# TECHNICAL SERVICE BULLETIN

REF.: AUDIO  
NO.: AU92-005  
DATE: OCT. 30, 1992  
MODEL: ALL MODELS

## '92 FUJITSU TEN 34210/34212 PIO/DIO CD PLAYER

#### **PRODUCTION CHANGE INFORMATION:**

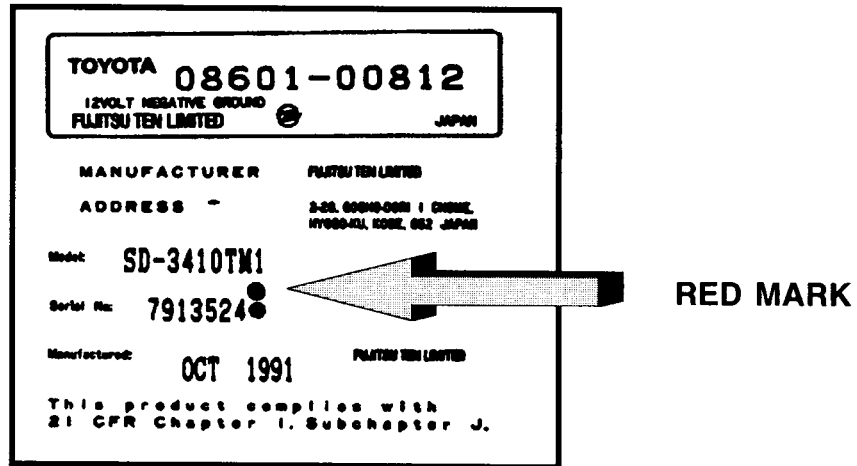
The CD mechanism has been changed to improve loading/eject operations on the 34210/34212 CD player.

Lever in the CD mechanism become misaligned causing the mechanism to jam during loading/eject operations.

Production change was made effective 2/92:

Model Number	Part Number Starting	Serial Number
34210	08601-00812	8500001-
34212 (Previa Only)	08601-00813	8500001-

Exchange the CD player.

Exchange CD players which have been countermeasured can be identified by a **RED MARK** next to the Serial Number on the bottom of the CD player. Fujitsu Ten started shipping countermeasured exchange CD players starting 6/92.
